**PRELIMINARY DRAINAGE REPORT  
FOR  
STERLING RANCH PHASE 2 PRELIMINARY PLAN**

**Engineering Review**

**October 1, 2020  
Project No. 25188.02  
SP-20-003**

STERLING RANCH PHASE 2  
PROPOSED DRAINAGE MAP  
JOB NO. 25188.00  
09/25/20  
SHEET 2 OF 2

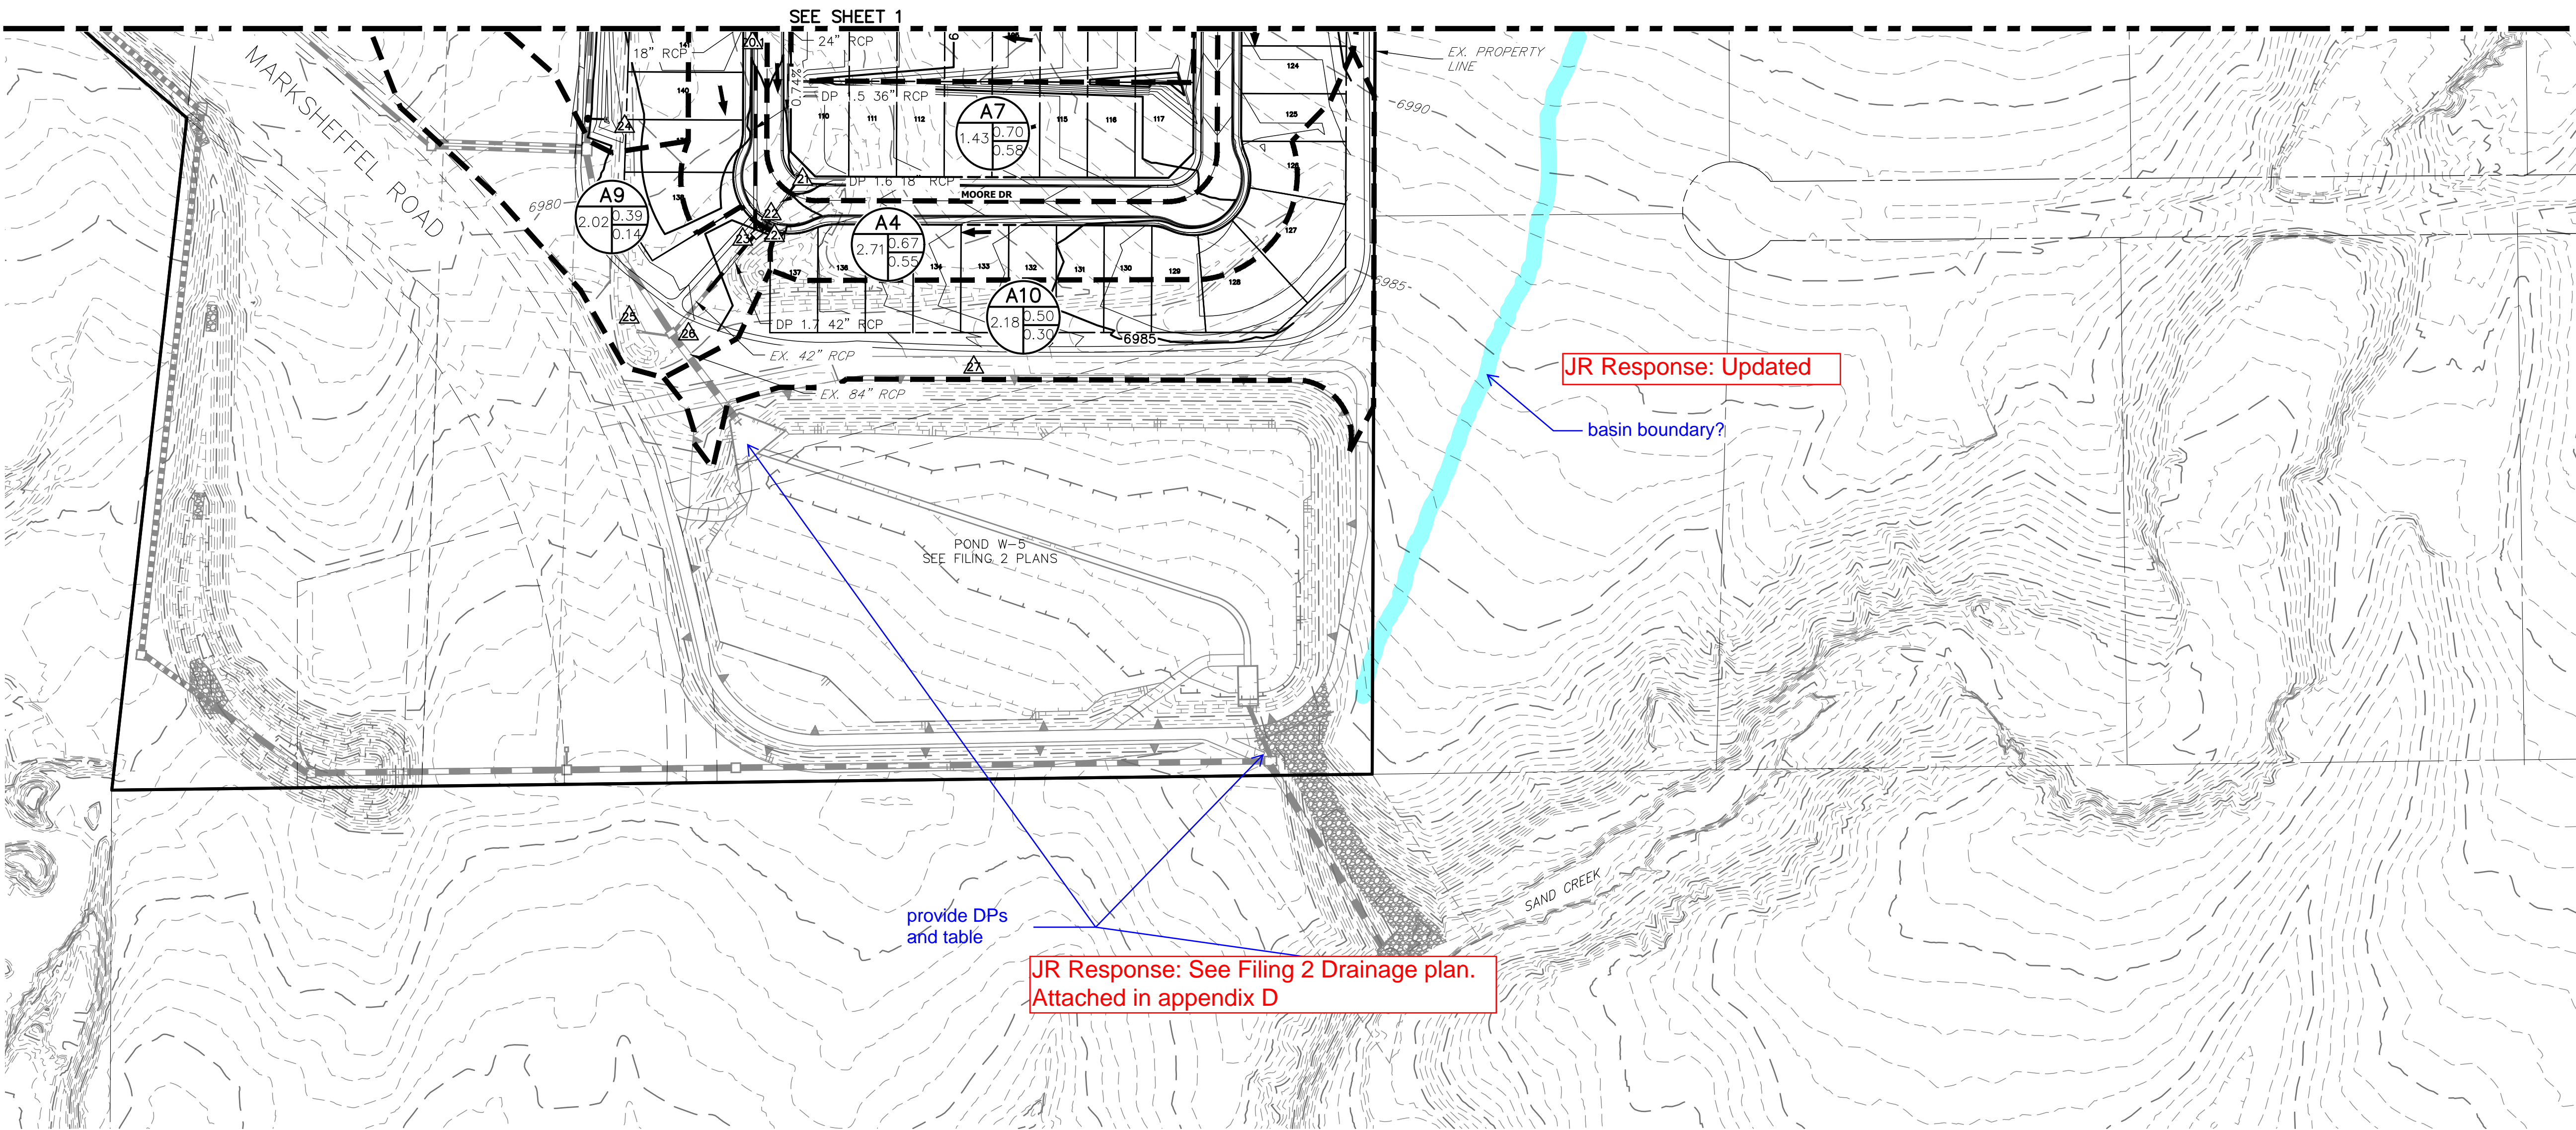
Also provide DP summary

JR Response: Updated

JR Response: Swale added. Overflow from sand filter should not be a problem overall runoff is minimal and no lots are directly behind the sand filter. See attached Barbarick report drainage map in Appendix D of this report

JR Response: Concrete channel added to back of lots. Sized to Carry overflow of existing Barbarick Detention pond.

JR Response: Added

JR Response: Yes, Labeled.

JR Response: Updated

JR Response: Updated

JR Response: Creek Being stabilized by JR engineering with separate project
